ADDENDUM NUMBER THREE

DARLA MOORE SCHOOL OF BUSINESS CONSTRUCTION – BP-3
ENCLOSURE/SITE/MEFP/INTERIOR
UNIVERSITY OF SOUTH CAROLINA
STATE PROJECT NUMBER H27-6069-AC-3

DATE OF ISSUE: June 22, 2012

FLOORBOX LAYOUT PLAN - LEVEL 01
REF. DWG #A1810
SHEET TITLE :

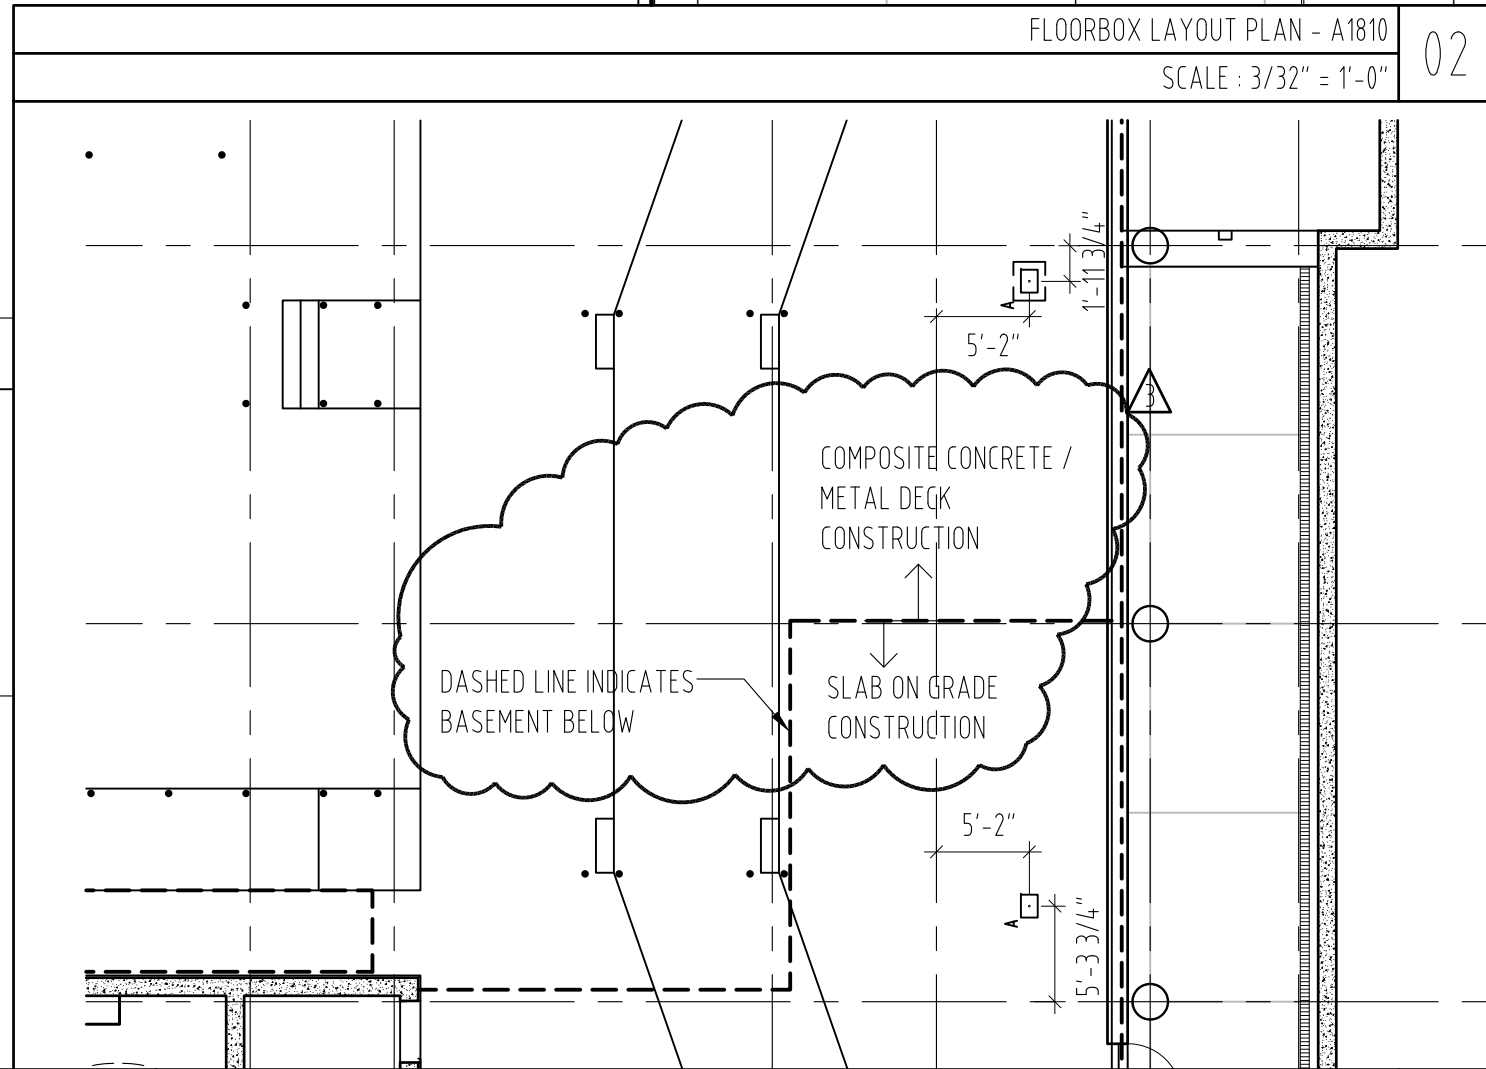
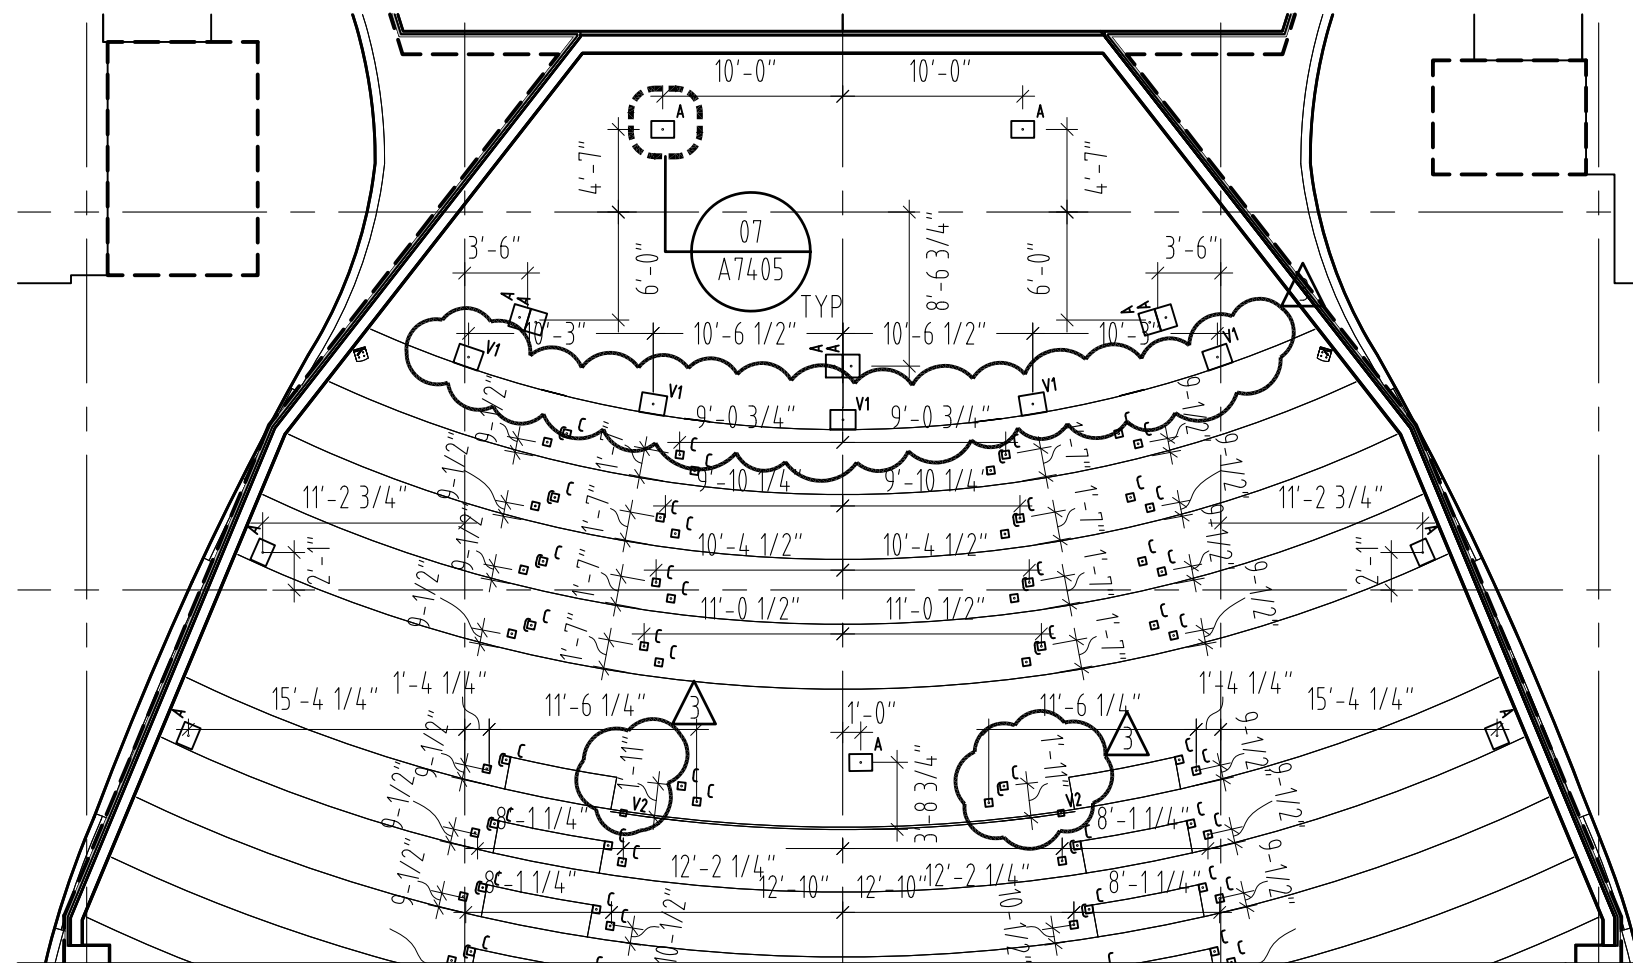
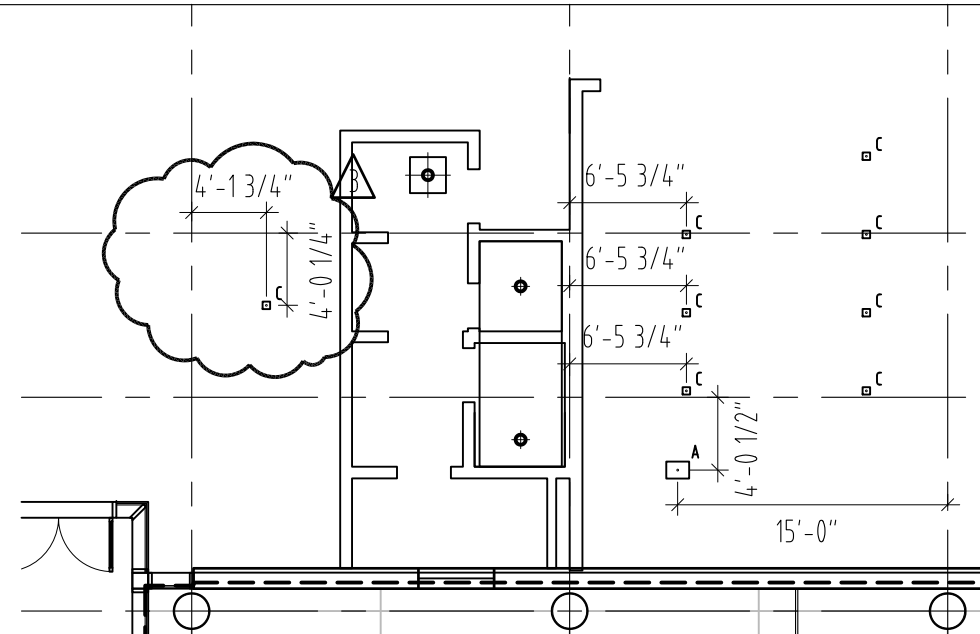
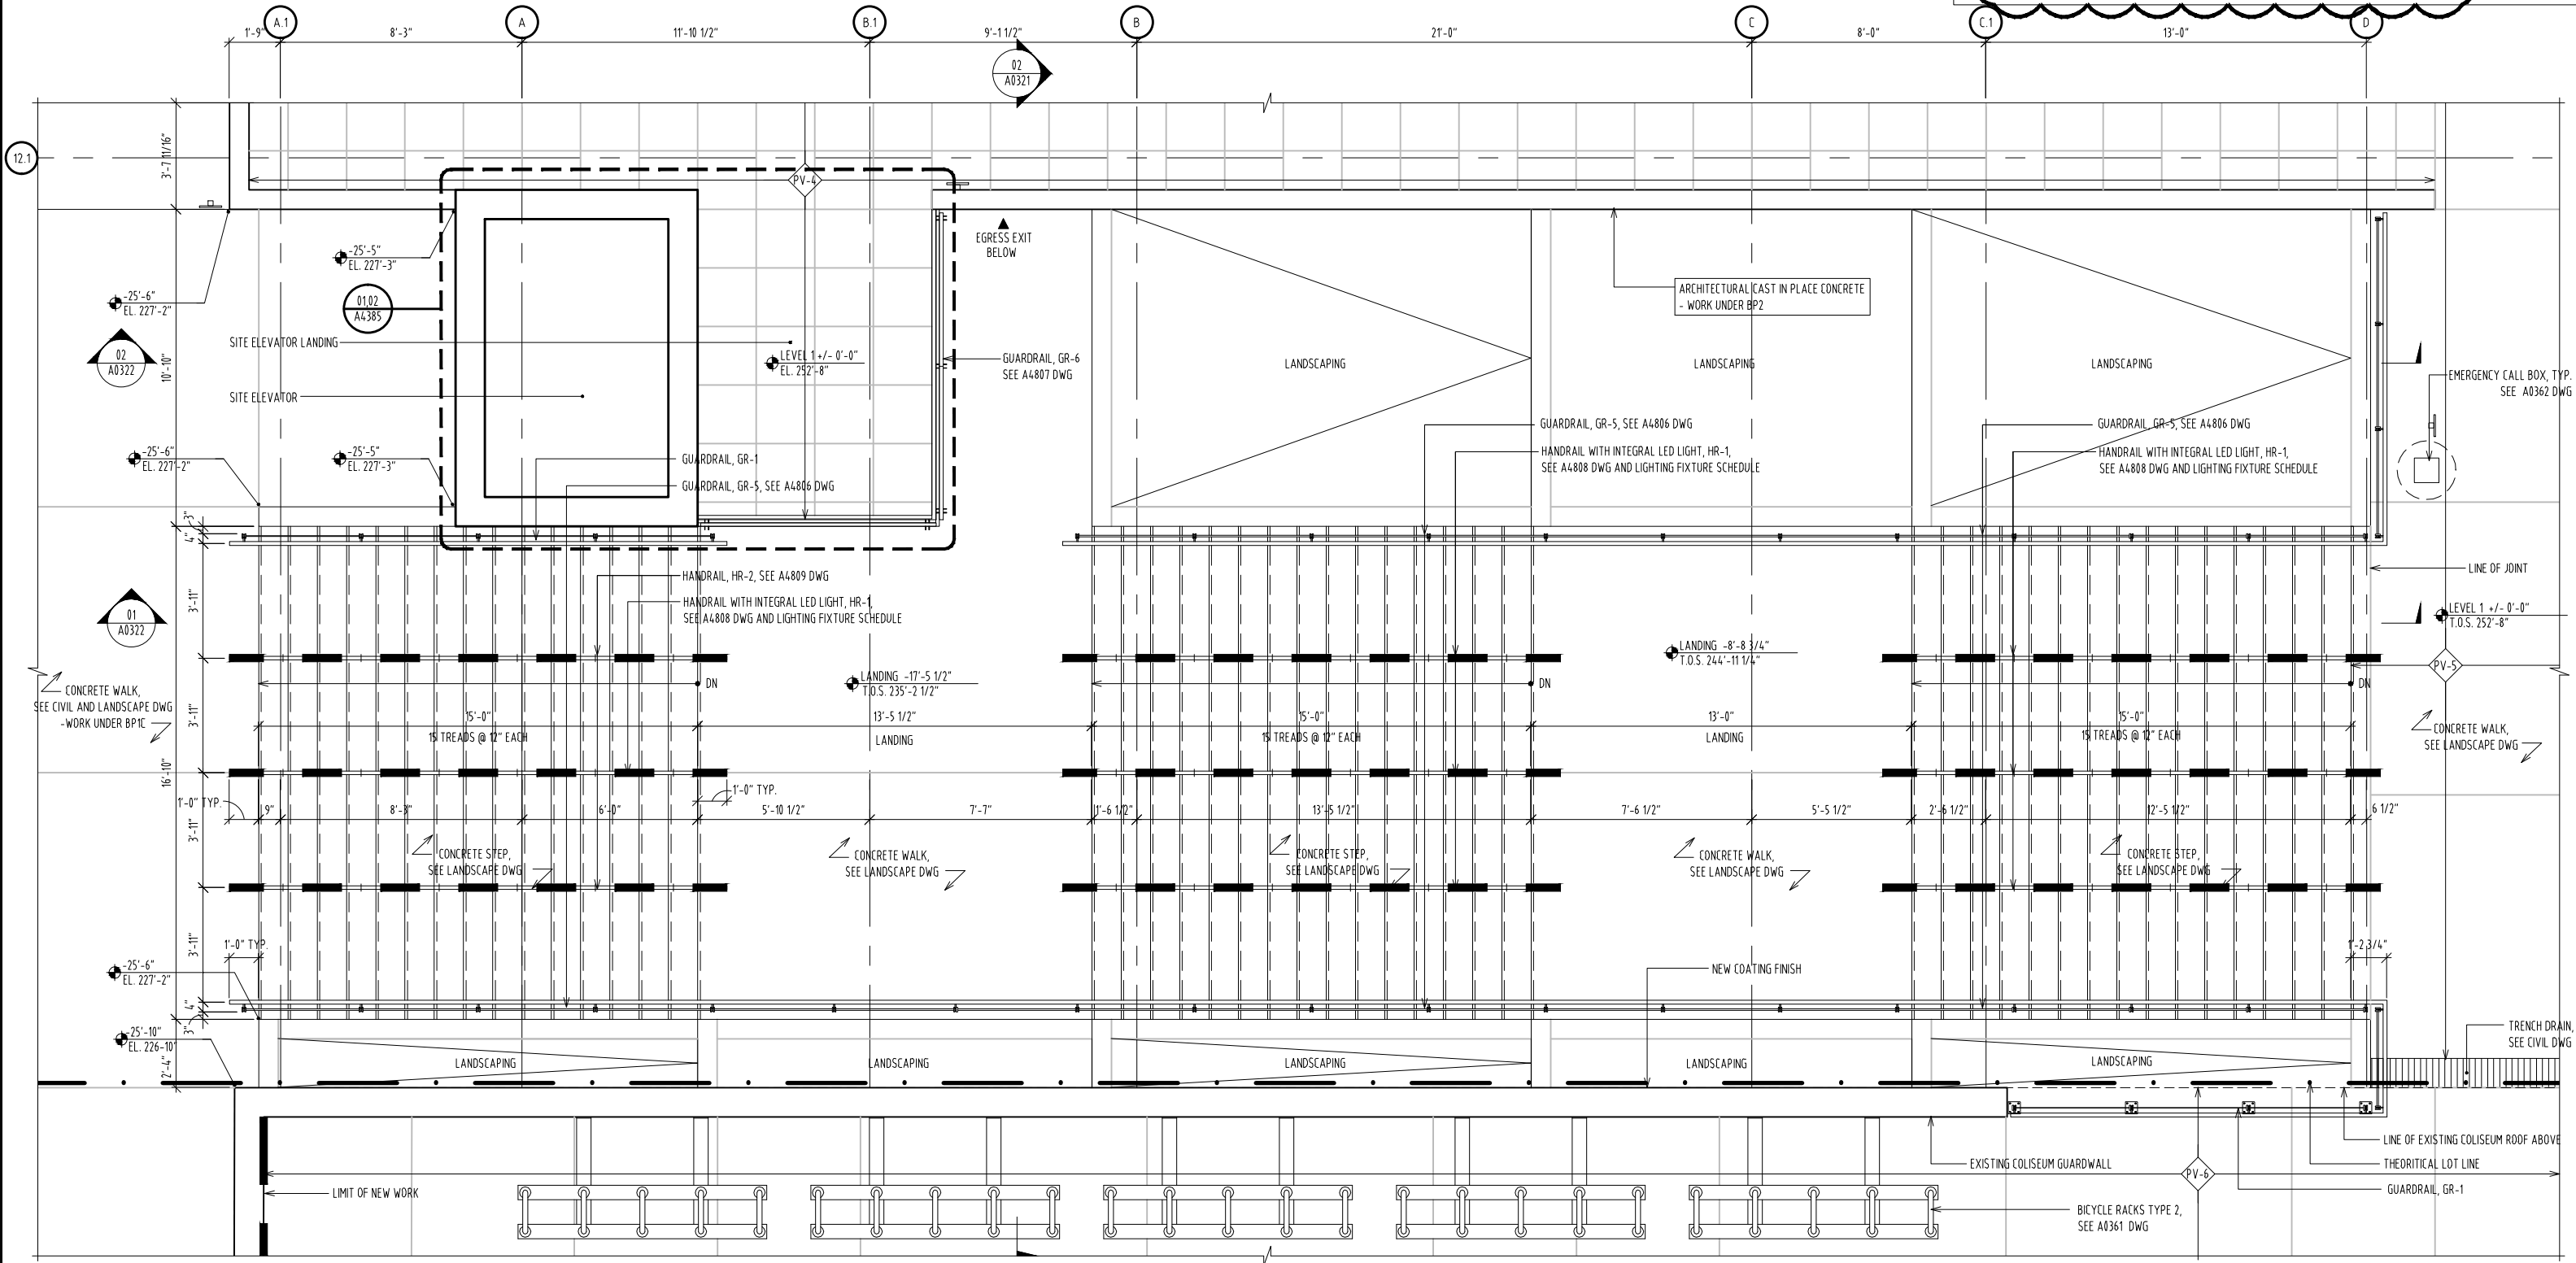
6. Sheet A1810: Floor box Layout Plan – Level 1. Refer to A-SK-058 – Revised floorbox layout
7. Sheet A0321 & 0322: Refer to attached sketch A-SK-059. Structural information – reference added.
